Memorandum

To: Planning Commission Members
From: Elizabeth J Corwin, PE, AICP; Planning Director
Date: April 3, 2025
Re: Special Land Use Approval and Site Plan Review for Jimmy John's and Dunkin'

Re: Site Plan Review
Jimmy John's/Dunkin
140 Highland Road
Sidwell No. 11-22-301-007

As requested, this office has reviewed the plans for the above-mentioned project as prepared by Kolbrook Design (plans not dated). The proposed improvements include renovation of an existing building for a proposed Jimmy John's and Dunkin food service with a drive thru. We have the following comments:

CLIENT: **KOLBROOK DESIGN**
ALTA/NSPS LAND TITLE SURVEY
SECTION: 22
140 W. HIGHLAND ROAD
TOWNSHIP: 3N
HIGHLAND TOWNSHIP
OAKLAND COUNTY
MICHIGAN
RANGE: 7E

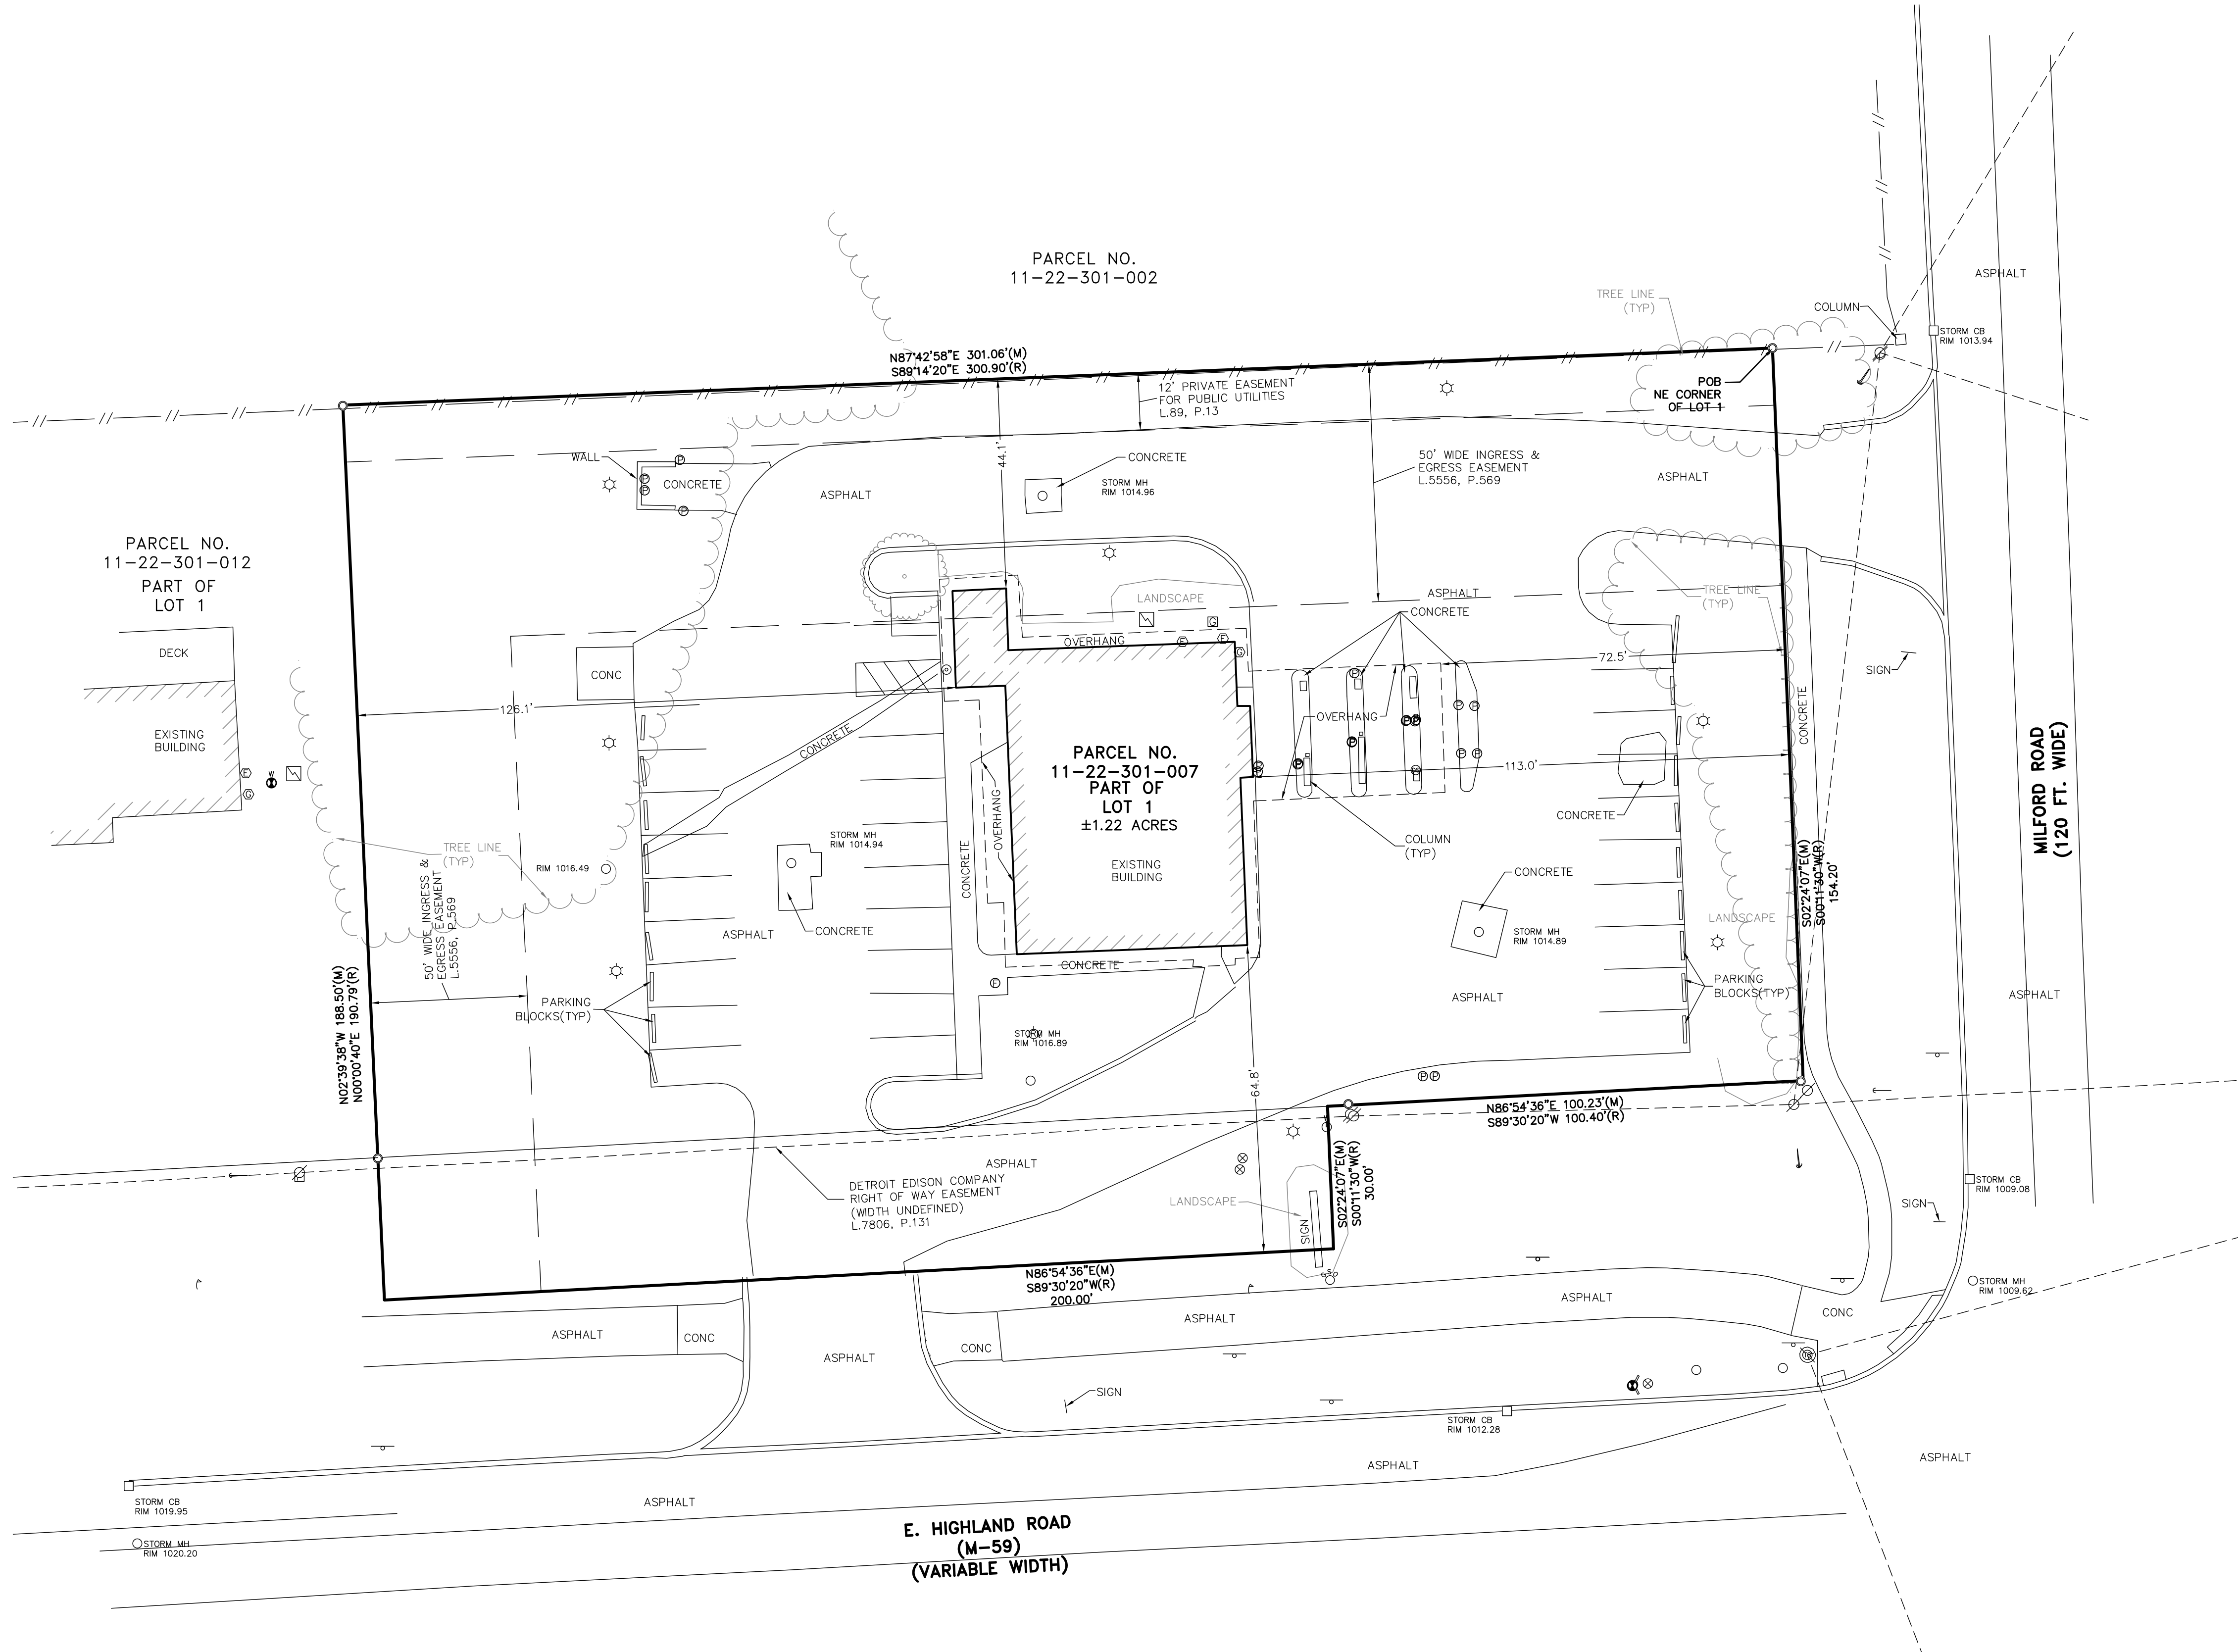
The site plan should be revised to accurately reflect the existing conditions for the adjacent sidewalks and multi-purpose path in the Highland Road and Milford Road rights-of-way. These are properly indicated on the Alta Survey, Sheet 1. The Milford Road sidewalk currently ends at the driveway and should be extended north to the property line.

The site plan indicates a proposed ground mounted sign along the Highland Road frontage. It does not indicate whether this is a reuse of the existing sign frame or a totally new installation. Based on the ALTA survey, it appears the existing sign and frame is in the ROW. The applicant should plan to develop a new sign, compliant with the zoning ordinance, located at least 10 feet from the ROW in both directions. (Section 14.07, Table 14.2.)

SITE PLAN
SCALE: 1" = 20'

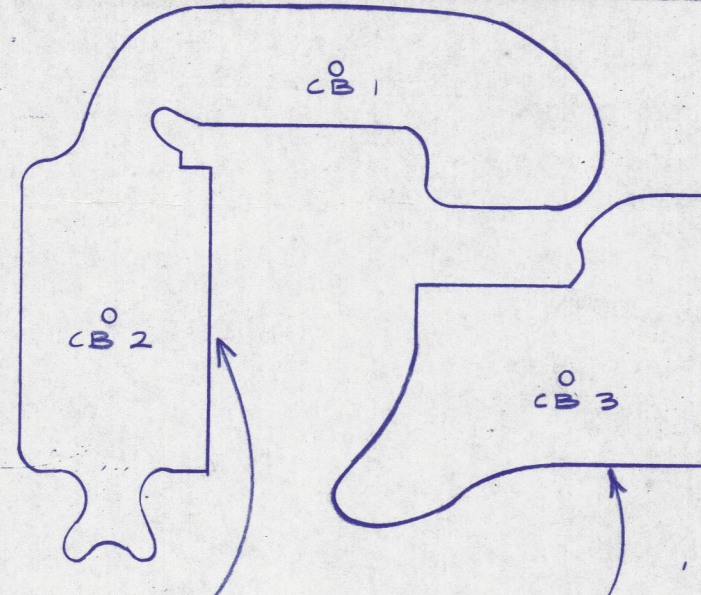
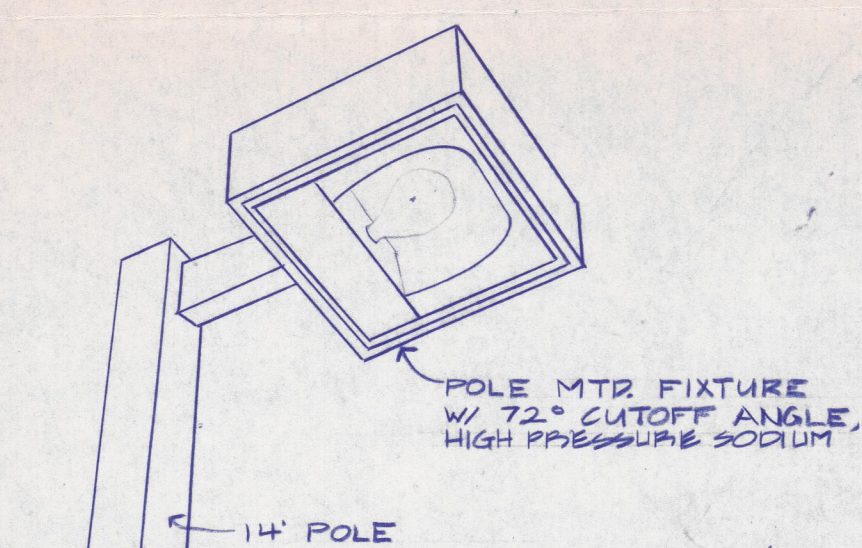
The applicant has not provided a lighting plan. The architectural plans call out recessed lighting under canopies and LED lighting above certain trim. There are some existing pole lights on the site, but there is no statement as to whether the applicant intends to retain these or replace these. The existing poles are indicated on the ALTA Survey and on the original site plans. More information is needed to assess the lighting plans, including a photometric study.

Landscaping: The applicant did not provide a landscaping plan. The existing site has some mature landscaping materials that could count toward the landscaping requirements, but overall, the site is need of selective clearing and possible replacement of some of the shrubs, particularly to address invasive species that have established themselves on the site. In particular, the site falls short of the buffer requirements adjacent to the Highland Road right-of-way and some of the internal landscaping requirements (see Sections 12.05 and 12.06 of the Zoning Ordinance.) See the original site plans and photos of the existing conditions of the site to aid your discussion.

There is no indication of the proposed grading plan or indication of what level of effort is anticipated in resurfacing those parts of the parking lot and drives that will be reused. The site was designed to drain via ten-inch diameter storm sewer and restricted orifice plates to the road drainage system, with flows exceeding the design flow stored on the parking lot surface. This is not a design approach that would be acceptable today.
